Ballard and Highland Ashland, MA

Depietri Group LLC
Sander Depietri

Conservation Commission Public Questions

Figure 3 – Post-Development Drainage Plan

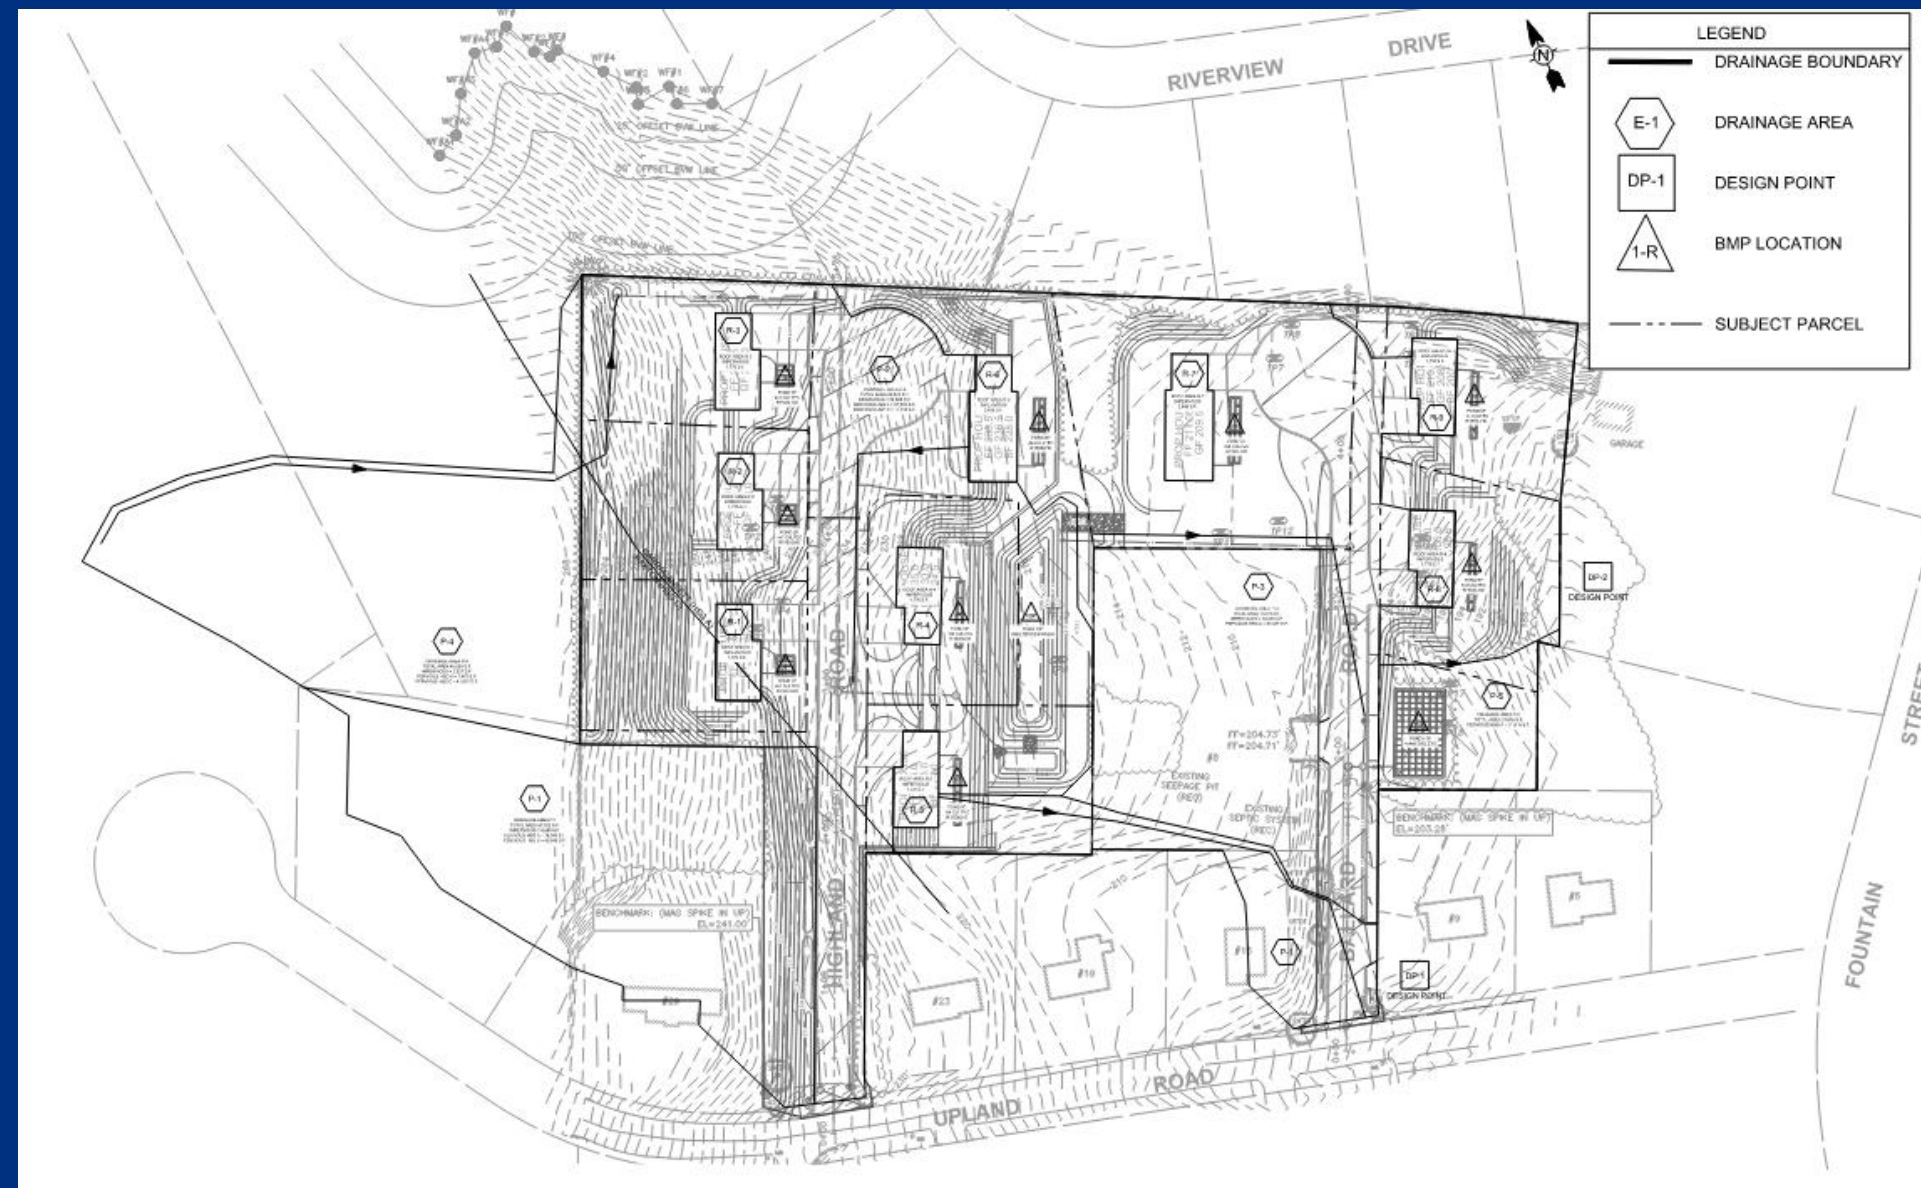
1. How the pond galley has been designed to manage stormwater volume during significant rainfall events.

2. Whether its location may alter drainage patterns in a manner that affects abutting properties.

3. What measures are in place to prevent prolonged ponding, overflow, or discharge toward neighboring lots.

Answer: The pond gallery is designed to attenuate peak stormwater flows and discharge overflow consistent with existing drainage patterns to the Upland Road municipal closed drainage system, as detailed in the Stormwater Management Report.

Answer: The proposed drainage design improves existing conditions and does not increase runoff to abutting properties, directing flows into the municipal closed drainage system in a controlled manner.

Answer: The site is graded to maintain positive drainage and prevent ponding, and any overflow during extreme events is directed to the municipal closed drainage system consistent with existing conditions.
